Access Compliance Report

Public Rights-of-Way

(Pedestrian Signals)

Intersection ID: N/A	Main Street:	Cross Street: N/A	Location: N/A
ADA ID: 4A951EA796D4	Signal Type: One Push Button-APS	Overall Compliance: No	Severity Score: BTN 1: N/A BTN 2: N/A No BTN: N/A
Codes/Mitigation Info/Possible Solution		Field Measurements/Component Compliance

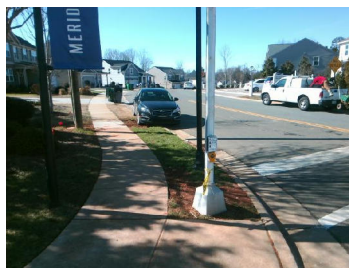
PROW/ADA: R404.2, R404.3, R404.7.2,
R209.1, MUTCD 4e.10

N/A	B 1 FWD Approach Width (in)	N/A	N/A	B 2 FWD Approach Width (in)	N/A
N/A	B 1 FWD Approach Obstruction?	Yes	N/A	B 2 FWD Approach Obstruction?	N/A
N/A	B 1 FWD Approach Obstruction Dist (in)	4.0	N/A	B 2 FWD Approach ObstructionDist (in)	N/A
N/A	B 1 PARA Approach?	Yes	N/A	B 2 PARA Approach?	N/A
N/A	B 1 PARA Approach Constrained?	Yes	N/A	B 2 PARA Approach Constrained?	N/A
Yes	B 1 PARA Approach Reach (in)	5.0	N/A	B 2 PARA Approach Reach (in)	N/A
No	B 1 PARA Approach Width (in)	54.0	N/A	B 2 PARA Approach Width (in)	N/A
N/A	B 1 PARA Approach Obstruction?	Yes	N/A	B 2 PARA Approach Obstruction?	N/A
N/A	B 1 PARA Approach Obstruction Dist (in)	5.0	N/A	B 2 PARA Approach ObstructionDist (in)	N/A
No	B 1 Clear Floor Space Slope (%)	3.1	N/A	B 2 Clear Floor Space Slope (%)	N/A
No	B 1 Clear Floor Space XSlope (%)	4.4	N/A	B 2 Clear Floor Space XSlope (%)	N/A
N/A	B 1 PAR Slope (%)	N/A	N/A	B 2 PAR Slope (%)	N/A
Yes	B 1 Height (in)	31.0	N/A	B 2 Height (in)	N/A

Possible Solutions: Remove & Replace
Replace APS Button With New APS Button.
Remove and Replace Clear Space.
